Access Compliance Report

Public Rights-of-Way

(Curb Ramps)

Intersection ID: 29291	Main Street: DUNNINGTON_CT	Cross Street: FOSTER_BROOK_DR	Location: NE
ADA ID: BF188D0F0165	Ramp Type: PerpDiag	Initial Pass/Fail: Fail	Overall Compliance: No
Severity Score: 10			
Codes/Mitigation Info/Possible Solution		Field Measurements/Component Compliance

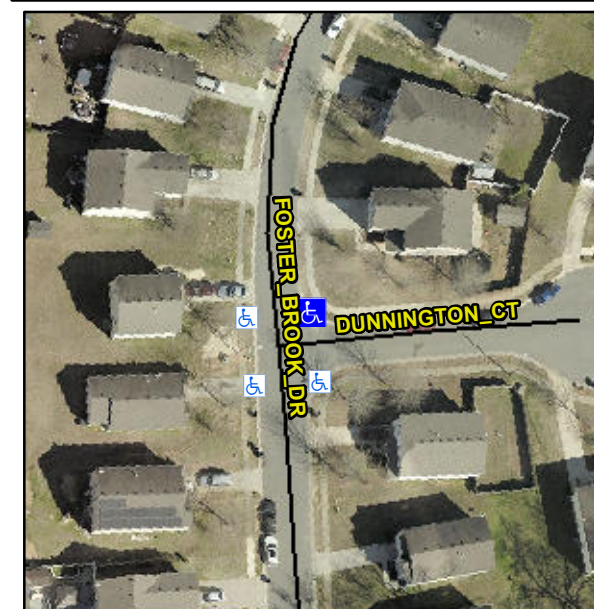
Not Found, R304.5.1, R304.5.3

Compliance	Description	Data	Compliance	Description	Data
N/A	Ramp Length (in)	48.0	Yes	Ramp Slope (%)	5.2
No	Ramp Width (in)	46.5	No	Ramp XSlope (%)	2.3
N/A	Flare Type LT	N/A	N/A	Flare Type RT	N/A
N/A	Flare Slope LT (%)	N/A	N/A	Flare Slope RT (%)	N/A
N/A	Flare Traversable LT?	N/A	N/A	Flare Traversable RT?	N/A
N/A	Landing Length (in)	N/A	N/A	DWS Provided?	N/A
N/A	Landing Width (in)	N/A	N/A	DWS Contrast?	N/A
N/A	Landing Slope (%)	N/A	N/A	DWS Length (in)	N/A
N/A	Landing X Slope (%)	N/A	N/A	DWS Full Width?	N/A
N/A	Landing Curb? (Y/N)	N/A	N/A	DWS Offset (in)	N/A
N/A	Shared Landing?	N/A			
N/A	Gutter Ponding?	N/A	N/A	Gutter Slope (%)	N/A
N/A	Gutter Lip Ht (in)	N/A	N/A	Gutter X Slope (%)	N/A
N/A	Painted X Walk1?	No	N/A	Painted X Walk2?	No
	X Walk 1 Direction	To W		X Walk 2 Direction	To S
N/A	X Walk 1 Width (in)	N/A	N/A	X Walk 2 Width (in)	N/A
	X Walk 1 Slope (%)	0.5		X Walk 2 Slope (%)	0.2
	X Walk 1 X Slope (%)	1.5		X Walk 2 X Slope (%)	2.3

Remove & Replace Curb Ramp With Two New Directional Ramps or Equivalent.
